## **ERCOT Independent Review of the CPS Energy (CPS) Omicron Reliability Project**

Date	Version	Description	Author(s)
07/26/2024	1.0	Final Draft	Sarah Gunasekera
		Reviewed by	Robert Golen, Prabhu Gnanam

## Executive Summary

Figure 3.1: Study Area Map Showing Project Need Seen by ERCOT

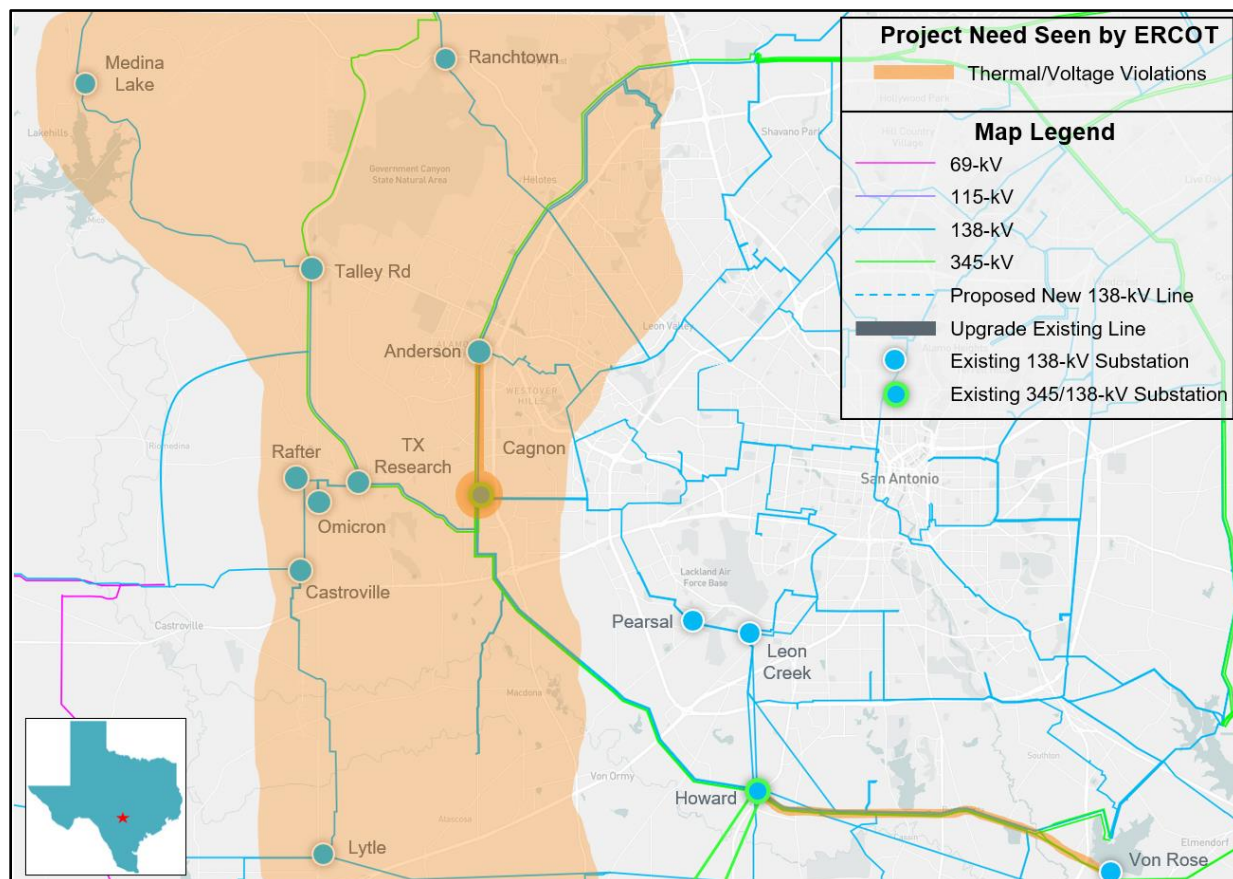
Steady-state reliability analysis was performed in accordance with NERC TPL-001-5.1 and ERCOT Planning Criteria described in Section 2.5 of this document. This analysis indicated two thermal overloads under X-1+N-1 contingency in the study area. Under the X-1 scenario with the Cagnon Auto Transformer 1 taken out of service, a thermal violation on the Cagnon to Anderson 138-kV line was observed. Under the X-1 scenario with the Hill Country Transformer 1 taken out of service, a thermal violation on the Howard to Von Rose 345-kV line was observed. Fifty-seven low voltage violations were observed in the study area under P7 contingency, and one low voltage violation was observed under P1 contingency. These violations were also seen under G-1+N-1 and X-1+N-1 contingency conditions. These issues are summarized in Table 3.1, Table 3.2, and Table 3.3 while visually illustrated in Figure 3.1.

NERC Contingency Category	Overloaded Element	Voltage Level (kV)	Length (~miles)	Max Loading %
P6-2: X-1+N-1	Cagnon to Anderson	138	4.6	101.2
P6-2: X-1+N-1	Von Rose to Howard	345	12.6	102.1

NERC Contingency Category	Bus Name	Voltage Level (kV)	Voltage (pu)
P7: N-1	36 <sup>TH</sup> Street	138	0.86
P7: N-1	Anderson	138	0.85
P7: N-1	Braunig Bus 1	138	0.88
P7: N-1	Braunig Bus 2	138	0.87
P7: N-1	Cagnon Bus 1	345	0.87
P7: N-1	Cagnon Bus 2	138	0.85
P7: N-1	Cagnon Bus 3	138	0.86
P7: N-1	Cagnon Bus 4	138	0.86
P7: N-1	Castroville	138	0.86
P7: N-1	Chavanea	138	0.87
P7: N-1	Crossroads	138	0.85
P7: N-1	Grissom	138	0.85
P7: N-1	Harlanda	138	0.88
P7: N-1	Helotes	138	0.85
P7: N-1	Hill Country Bus 1	345	0.88
P7: N-1	Hill Country Bus 2	138	0.86
P7: N-1	Hill Country Bus 3	138	0.86
P7: N-1	Hill Country Bus 4	138	0.86
P7: N-1	Howard Bus 1	345	0.87
P7: N-1	Howard Bus 2	138	0.87
P7: N-1	Hunt_Ln	138	0.86
P7: N-1	Leon Creek	138	0.88
P7: N-1	Lytle Bus 1	138	0.87
P7: N-1	Lytle Bus 2	138	0.87
P7: N-1	Mauermann	138	0.87
P7: N-1	MedinaBS	138	0.87
P7: N-1	Palo Alto	138	0.88
P7: N-1	Pearson Switching Station	138	0.86
P7: N-1	Pinn_Rd	138	0.86

Figure 4.4: Map of Study Area with Option 1B

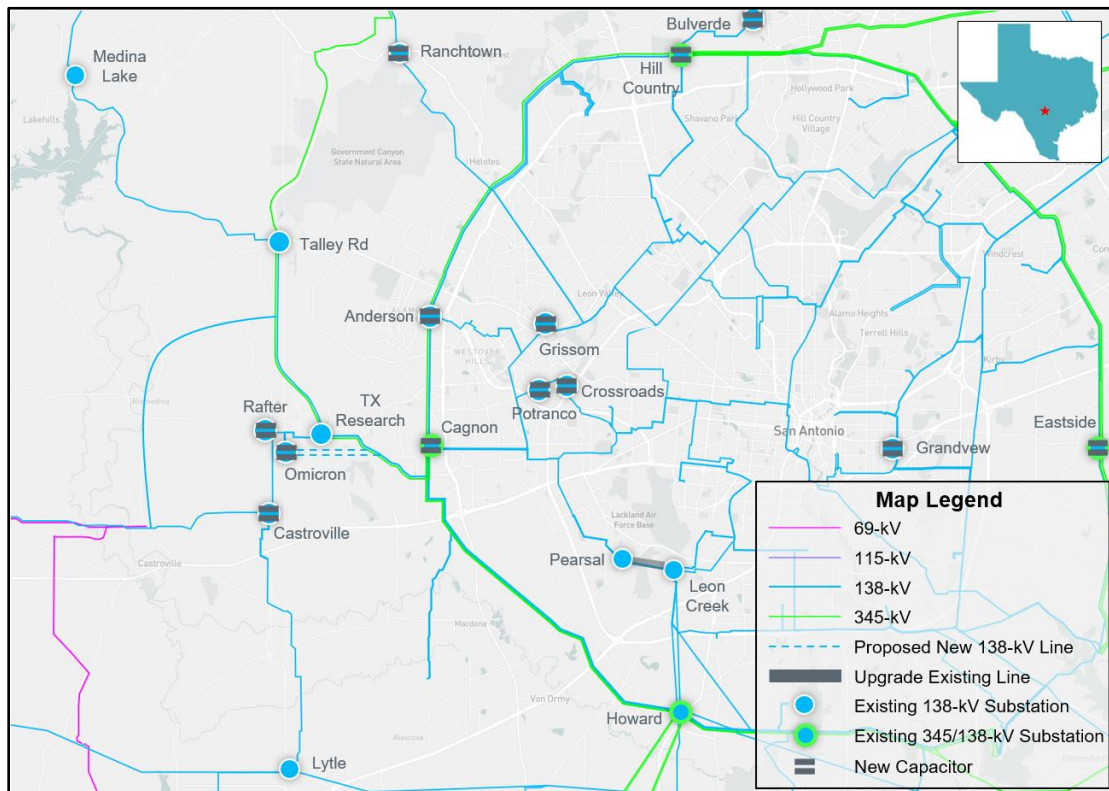
Option 1B consists of the following:

- Construct a new approximately 5-mile line extension from the new Omicron 138-kV substation to the existing Cagnon to Howard 138-kV transmission line. This creates a new Cagnon to Omicron 138-kV transmission line and a new Howard to Omicron 138-kV transmission line with normal and emergency ratings of 698 MVA per circuit;

- Rebuild the existing Leon Creek to Pearsal 138-kV transmission line with normal and emergency ratings of at least 478 MVA, approximately 1.7-mile;
- Install a new 28.57 MVar capacitor bank at the existing Rafter 138-kV substation;

ERCOT recommends Option 1B as the preferred option to address the reliability need in the San Antonio area based on the following considerations:

- Option 1B addresses project need in the study area;
- Option 1B is the least expensive option;
- Option 1B provides better long-term load-serving capability; and
- Option 1B requires the least mileage of CCN.

Figure 8.1: Map of Study Area with Option 1B

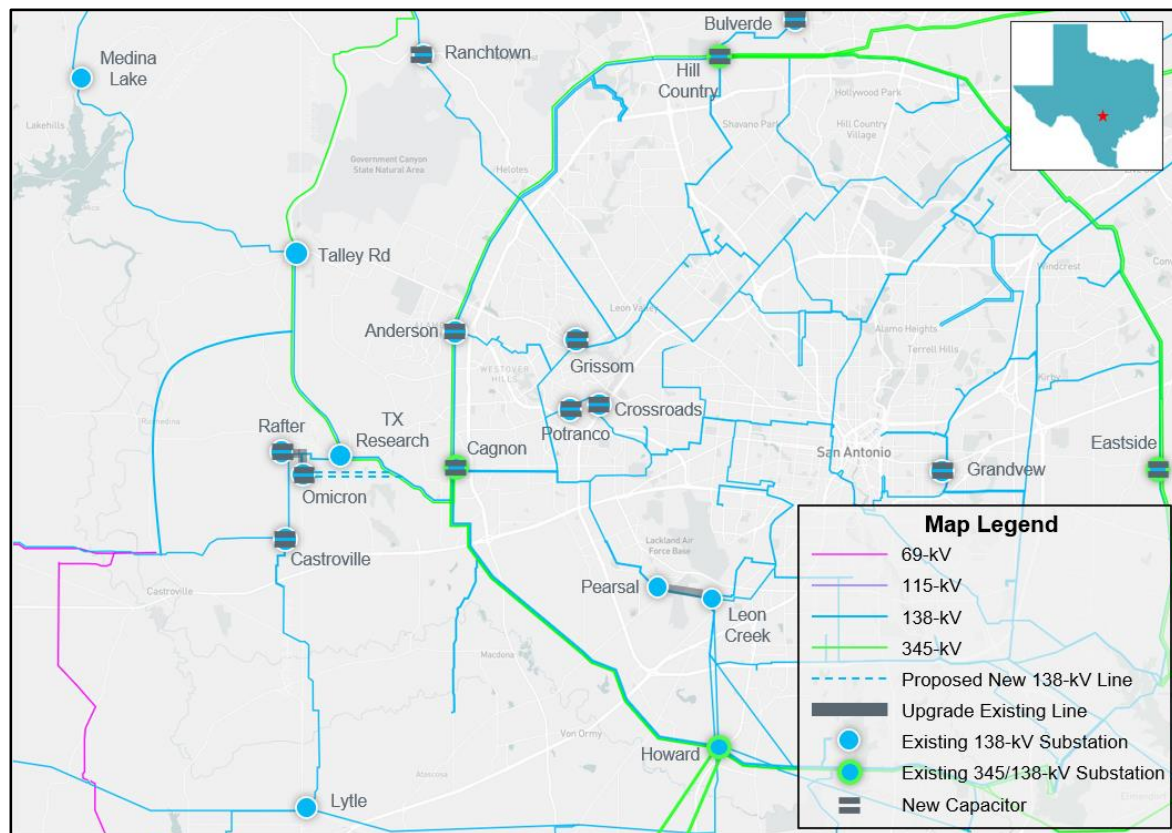
This review also reveals that Option 1B should be supplemented with the following economic project:

- Rebuild Omicron to Rafter 138-kV transmission line with normal and emergency ratings of at least 570 MVA, approximately 1.7-mile.

Option 1B consists of the following upgrades and is estimated to cost \$45.7 Million:
